TECHNICAL DRAINAGE STUDY RESPONSE TO CCRFCD COMMENTS

Skye Canyon Detention Basin 2

**Subject: Addendum to the Technical Drainage Study for Skye Canyon Basin #2 (DS4813C)
(CCRFCF No. 18-10010)**

**DISTRICT COMMENT(S): SKYE CANYON- DETENTION BASIN #2
(DS4813C) (RFCD No. 18-10010)**

Emergency Spillway Calculations

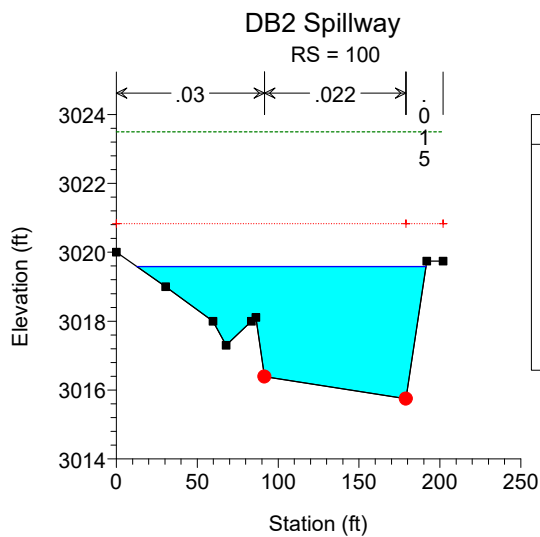
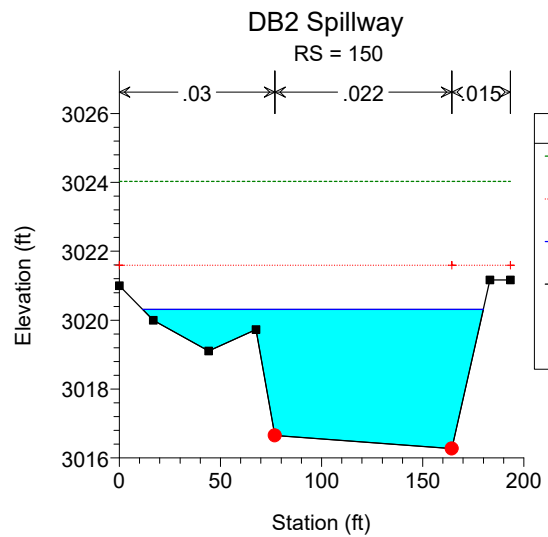
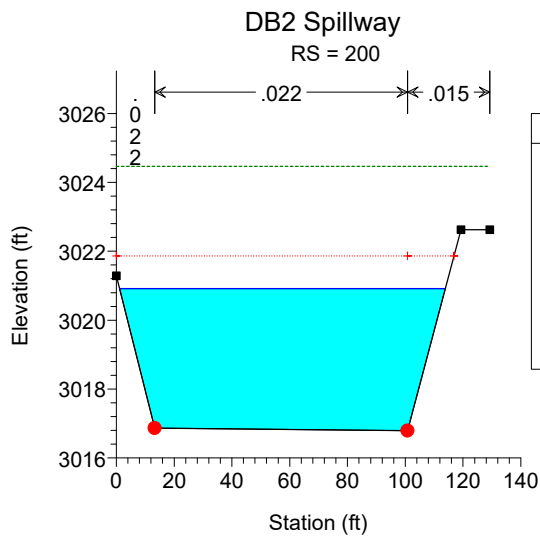
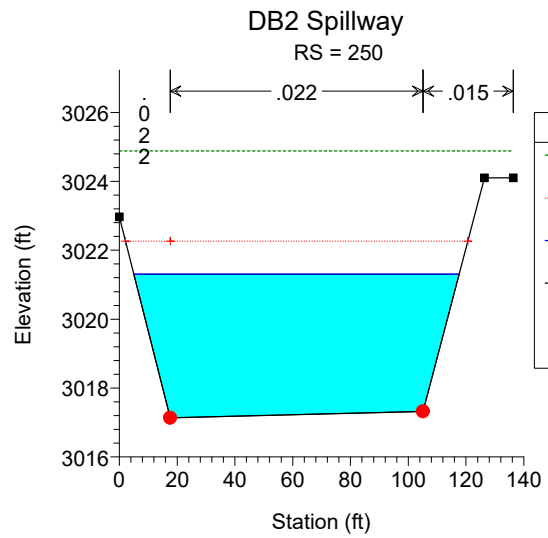
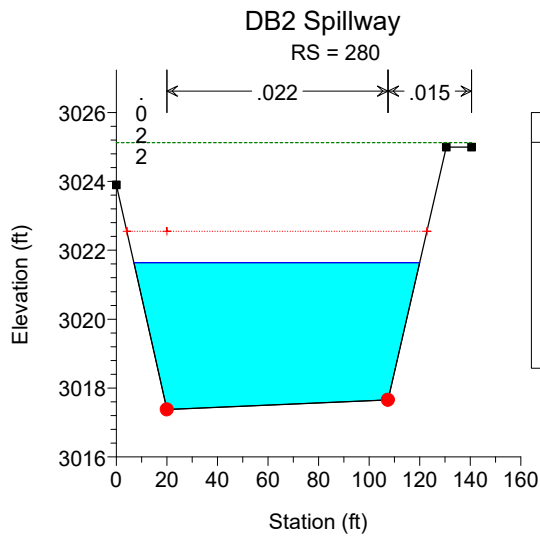
2. **Comment:** *Provide discussion and emergency spillway sizing calculations to support the currently proposed 12-ft spillway as shown on Details 1/D-2 and 3/D-3. Additionally, provide detail cross section for the entire emergency PMF spillway section to include the slope to the base of the spillway at the 102-ft Nevada Energy Easement.*

Response: The emergency spillway for the basin is located such that the overflow passing out of the basin during a PMF event will be discharged into the future Iron Mountain Road alignment, which is considered to have the least impact to future development. The crest is proposed diagonal to the spillway alignment, resulting in a 140-ft crest length. A Flowmaster generic weir calculation was performed with the original TDS submittal showing a 5.79-ft depth, which resulted in over a foot of freeboard to the adjacent east spillway embankment. An updated calculation (see Appendix) has been performed using a broad-crested weir calculation that takes into account the downstream tailwater depth. The results of this calculation show a depth over the weir of 5.85-ft, which is within a tenth of the original calculation, and still provides greater than a foot of freeboard during the PMF event.

A HEC-RAS model was performed (see Appendix) for the spillway channel, which narrows to an 87.5-ft base width downstream of the 140-ft long weir crest. Results of the model show a flow depth of 4.26-ft immediately downstream of the weir, which is the value used for the tailwater in the weir calculation. The flow depth decreases at each downstream cross section to a depth of 3.84-ft at the termination of the east embankment. Flow velocity and scour potential, and measures proposed to

Trash Rack Capacity Calculations

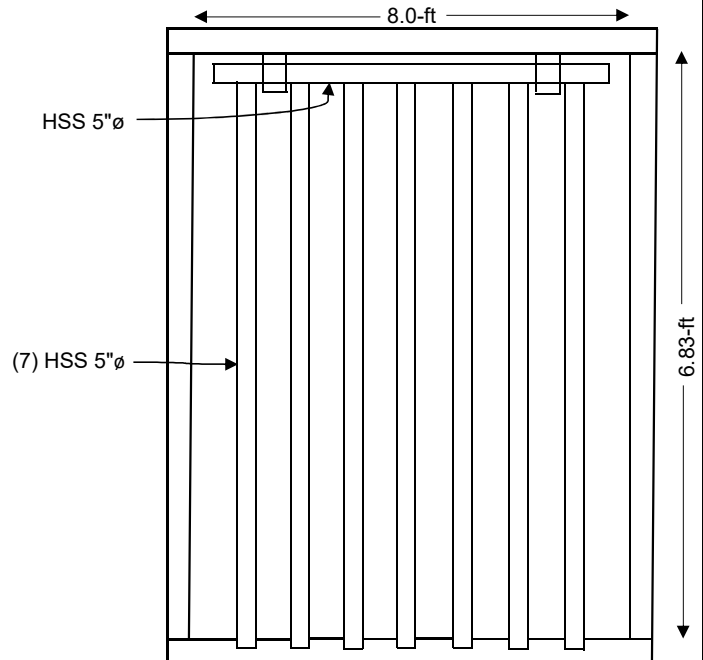
6. Provide a copy of the approved Emergency Action Plan (EAP) for the proposed detention basin to the District upon availability.
7. Provide trash rack capacity calculations to verify that the grate opening is adequate with 50% clogging factor.

Response: Trash rack capacity calculation included in Appendix. Computations verify adequacy with 50% clogging factor.

Capacity of grate with 50% clogging factor exceeds capacity of orifice outlet, therefore grate size is sufficient.
